Access Compliance Report

Public Rights-of-Way

Intersection ID: 48320	Main Street: NORTHLAKE_MALL_DR	Cross Street: NORTHLAKE_COMMONS_BV	Location: SE
ADA ID: A9446416A7F4	Ramp Type: Para	Initial Pass/Fail: Fail	Overall Compliance: No
		Severity Score: 12.5

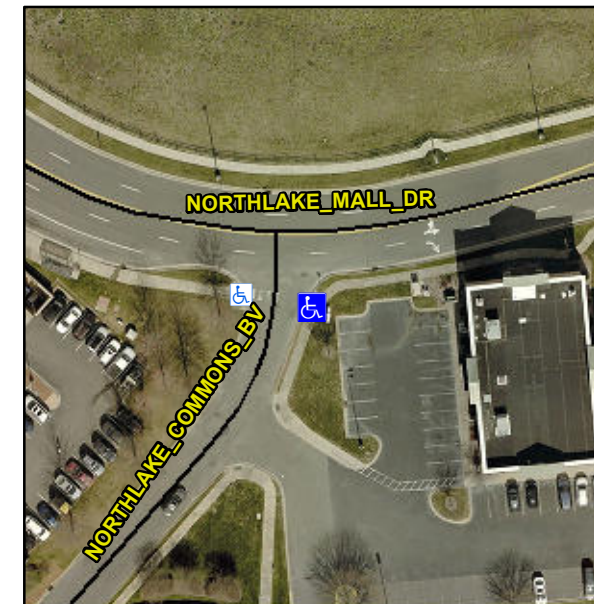
R304.3.2

Compliance	Description	Data	Compliance	Description	Data
N/A	Ramp Length LT (in)	58.0	N/A	Ramp Length RT (in)	72.0
Yes	Ramp Width LT (in)	83.0	Yes	Ramp Width RT (in)	84.0
No	Ramp Slope LT (%)	8.5	Yes	Ramp Slope RT (%)	7.7
Yes	Ramp XSlope LT (%)	0.1	Yes	Ramp XSlope RT (%)	1.0
N/A	Landing Length (in)	N/A	N/A	DWS Provided?	N/A
N/A	Landing Width (in)	N/A	N/A	DWS Contrast?	N/A
N/A	Landing Slope (%)	N/A	N/A	DWS Length (in)	N/A
N/A	Landing X Slope (%)	N/A	N/A	DWS Full Width?	N/A
N/A	Landing Curb? (Y/N)	N/A	N/A	DWS Offset (in)	N/A
N/A	Shared Landing?	N/A			
N/A	Gutter Ponding?	N/A	N/A	Gutter Slope (%)	N/A
N/A	Gutter Lip Ht (in)	N/A	N/A	Gutter X Slope (%)	N/A
N/A	Painted X Walk1?	Yes	N/A	Painted X Walk2?	N/A
	X Walk 1 Direction	To W		X Walk 2 Direction	N/A
N/A	X Walk 1 Width (in)	60.0	N/A	X Walk 2 Width (in)	N/A
	X Walk 1 Slope (%)	2.6		X Walk 2 Slope (%)	N/A
	X Walk 1 X Slope (%)	0.4		X Walk 2 X Slope (%)	N/A
N/A	Ramp inside XWalk1?	Yes	N/A	Ramp inside XWalk2?	N/A

Remove & Replace Entire Ramp.
